CITY OF WEST TORRENS

COUNCIL ASSESSMENT PANEL

8.1 239, 241-243 Richmond Road, RICHMOND

Application No 21028599

Figure 1

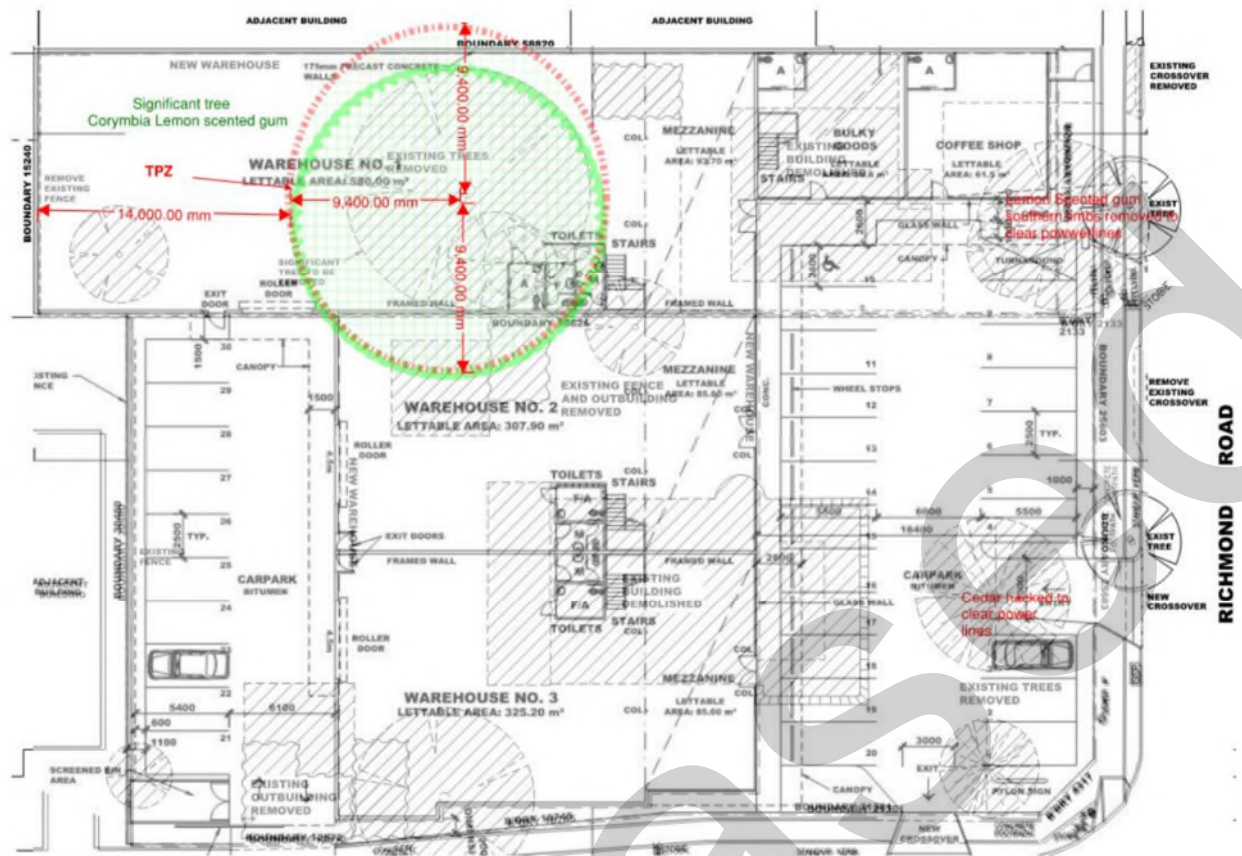
3. The Regulated Tree (Lemon Scented Gum) is located approx. 7.5 metres from the eastern boundary and approx. 14.0metres from the main section of the northern boundary. The tree has a canopy of some 22.0 metre with a circumference of 2.45 metres measured at 1.0 metres above ground (DBH). The tree will have a Tree Protection Zone (TPZ) radius of approx. 9.40 metres.

The Figure 1 below shows the location of the Regulated Tree in relation to the eastern and northern boundaries, and the proposed warehouses. The Red circle is the approximate extent of the TPZ.

Figure 2 Access Prohibited Zones

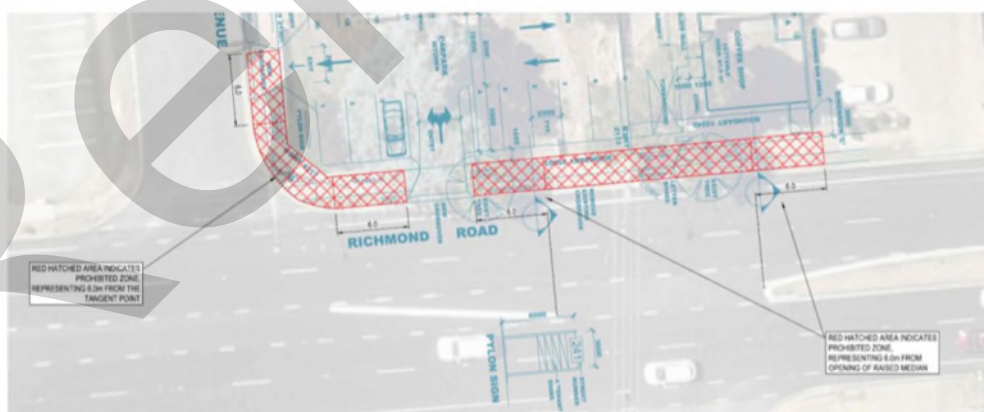
The proposed development will have an access point on Richmond Road and two access points on Chambers Street. The Richmond Road access point has been identified by DIT as not meeting the requirements of Major Transport Routes Overlay DTS/DPF 4.1 – Access – Location (Spacing) – New Access Points. A review of the site with regards to the requirements of the P&D Code has found there is limited opportunity for an access point on Richmond Road.

3.1 Parking Layout

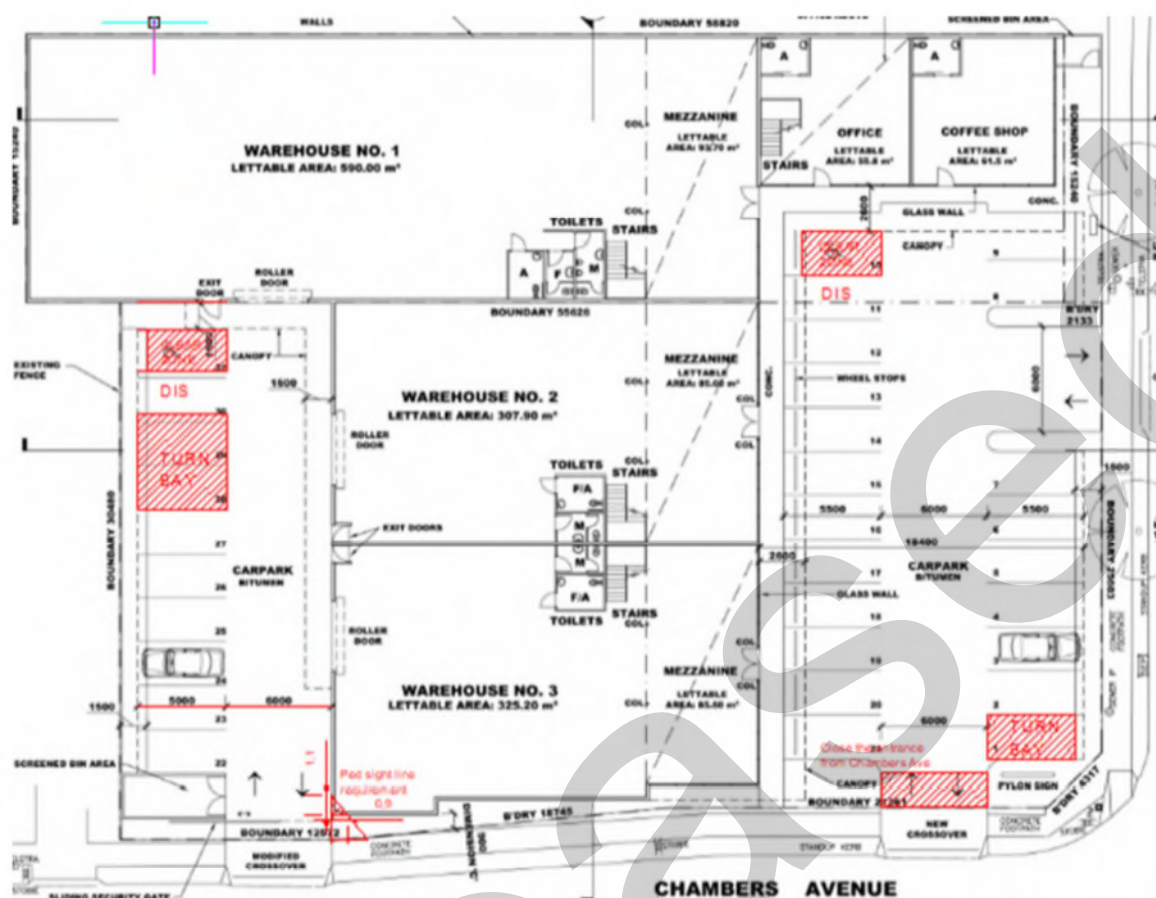
There are a number of amendments required to the parking layout to enable the layout to meet the requirements of the current parking standards and also to deal with the servicing aspects of the proposal.

I note that there is limited information provided regarding service vehicles that may require access to the warehouses other than the comment that the warehouses would be 'used by occupiers who do not require large vehicle access to the warehouse facilities' (see Rod Roach Architecture Report August 2021 Page 2). Given the constrained nature of the rear car park (Chambers Avenue) where the roller doors of the warehouses are located, my assessment indicates that the 6.4m long SRV truck (as per AS 2890.2-2018) would be able to access the warehouses and rear car parking layout. Vehicles larger than the SRV would not be able to access the roller doors. A condition restricting service vehicles to SRV size for the proposed 3 warehouses would be appropriate.

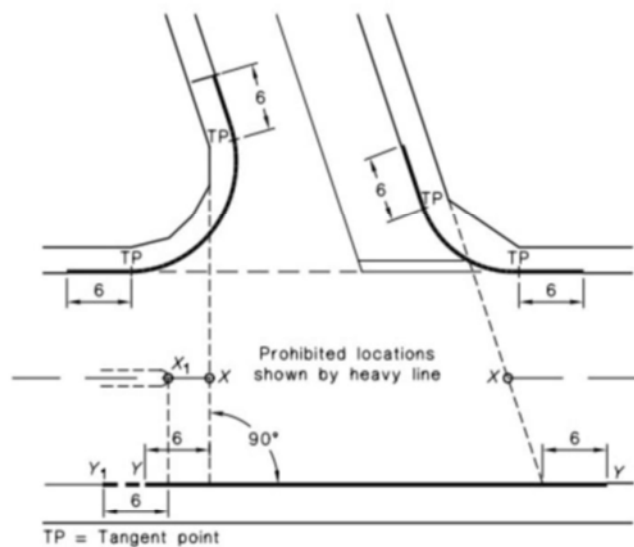
I refer to our discussions concerning the above appeal matter. You have asked for my opinions about the proposed access points and car park layout as shown in the revised plans (more particularly Drawing DA 2A dated March 2022).

The above drawing shows an ingress-only access point from Richmond Road into the proposed front car park of the development, with an egress-only access point to Chambers Avenue. At the rear of the proposed building, a car park with two-way access to Chambers Avenue is proposed.

I have previously provided traffic assessment advice for the above development on 24/1/2022. At the time, the front car park of the development was proposed to have a two-way access point on Richmond Road (opposite Aldridge Road), a two-way access point on Chambers Avenue and the rear car park was proposed to have a two-way access point on Chambers Avenue. At the time of my assessment, I expressed a number of concerns regarding the proposed parking layout, the location of the Richmond Road access point opposite Aldridge Road and the lack of information regarding the service vehicles that would access the rear of the proposed tenancies.

2. **Proposed egress-only access point on Chambers Avenue** – Having regard to the Stantec assessment, DIT's alternative suggestion to provide a two-way access point at this location and Figure 3.1 of AS/NZS 2890.1:2004, on balance, I consider the proposed egress-only arrangement to be acceptable. Instead of the egress driveway being located centrally as shown in the revised drawing, I recommend that the alignment be shifted slightly northwards so that the driveway alignment is in line with Space 20, so as to maximise the separation distance from the tangent point, albeit the 6m separation requirement would still not be satisfied.
